HORSHAM DISTRICT COUNCIL CONSULTATION

TO:	Horsham District Council – Planning Dept
LOCATION:	Land West of Billingshurst Road, Ashington
DESCRIPTION:	Outline application with all matters reserved except access, for up to 65 dwellings, access from Billingshurst Road, parking, landscaping, open space, sustainable drainage and associated infrastructure.
REFERENCE:	DC/26/1037
RECOMMENDATION:	More Information / Modification

Mitigation & Strategic Objectives

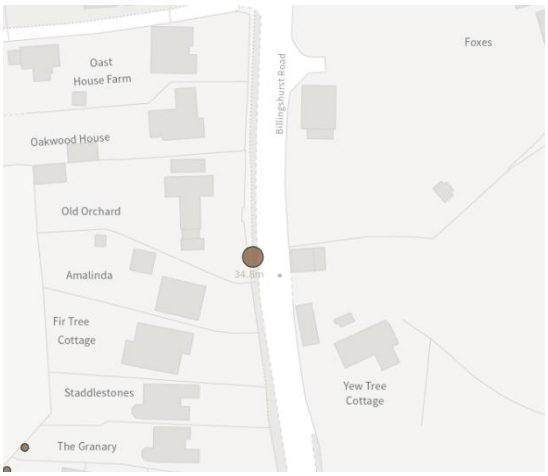
22. A number of Mitigation measures and Strategic Objectives have been identified in both the LVA and Landscape Design Strategy respectively. These are generally appropriate in principle, including retention of vegetation, reinforcement of hedgerows, native planting, habitat connectivity and a landscape buffer beside the PRoW. However, they do not appear to be carried through into the proposals. These include, amongst others:

a. *Retention of the historic field patterns through the setting back of development from historic or established boundaries.* – as discussed below a number of well established hedgerows is proposed for removal.

b. *Protection and retention of the existing boundary vegetation and reinforcement through native shrub and tree planting* – refer to paragraphs 27 and 28 below.

c. *Incorporation of exiting long views to distant ridges whilst respecting existing field patterns, as described within landscape management guidelines* – long distance views not indicated in the parameter plan and not demonstrated in the landscape strategy or illustrative masterplan.

d. *Enhancing the Site frontage along Billinghurst Road, integrating the Site into the semi-rural streetscape through suitable planting and well-designed boundary treatment* – not demonstrated through the illustrative masterplan.

e. Provision of high quality street scenes achieved by planting of compact canopy, ecologically valued tree species within the built area - not demonstrate through the illustrative masterplan.

TPO 1496

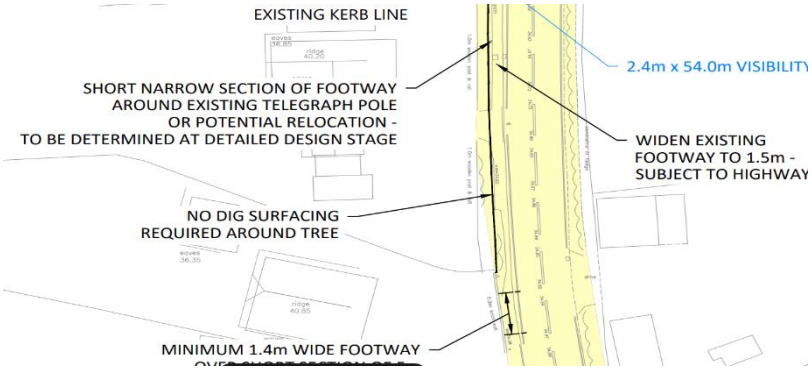
28. The Tree officer raised concerns with the offsite highway improvement works proposed along Billingshurst road. The widening of the footway and other highway upgrading works are likely to require excavation and engineering works within the root protection areas of several roadside oak trees, including the Oak protected by TPO/1496 (in front of Old Orchard's boundary), but this is not clear from the information provided. The submitted information does not adequately demonstrate how these works could be achieved without harm to the trees, a recognised landscape feature. Please refer to extracts below. While it is recognised that these works may be necessary, the impact on the TPO tree must be fully understood so that an informed decision can be made.

Photo 1 Looking towards TPO 1496 in a southerly direction. Photo 2 Looking towards north in close proximity to the tree showing how tight the existing footpath is due to the position of the large tree trunk
